WIRING DIAGRAM

COMP. No	DRG. No
123332	WD-0359

TTV-678 WIRING DIAGRAM

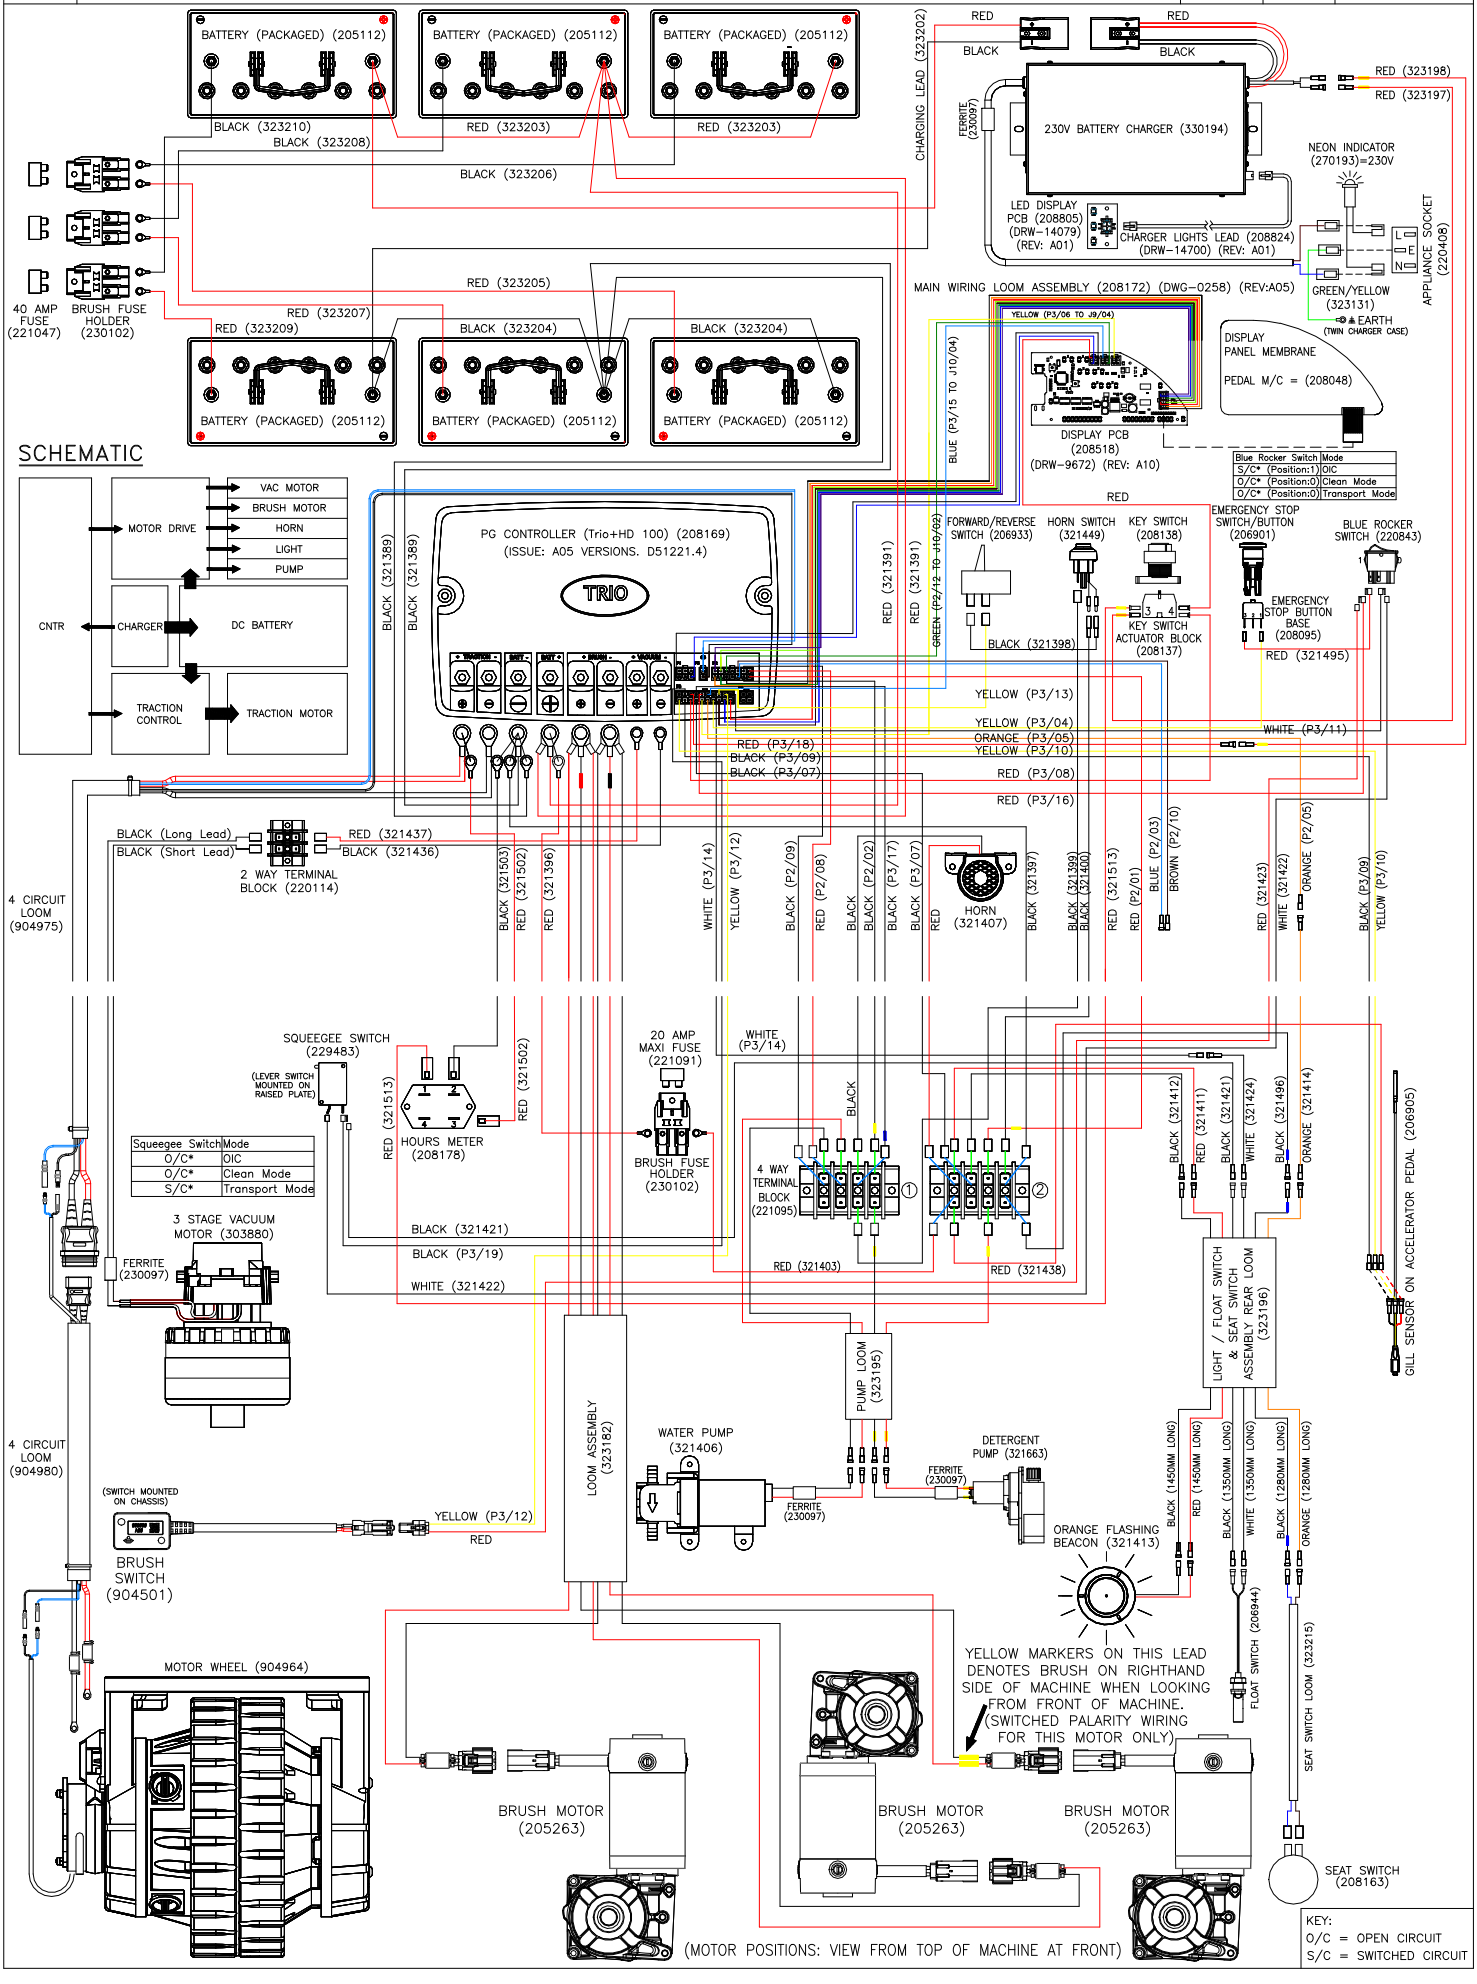
ISSUE	REVISION	DRAWN	APPD.	DATE
A26	35 CIRCUIT LOOM (208172) LOOM UPDATED TO ADD 2 WAY MIZU CONNECTOR & RED WIRE. LINK WIRE (321423) DELETED. BRUSH SWITCH (208748 REPLACED WITH (904501) PROJ-1220	AM	MB	18/05/2017
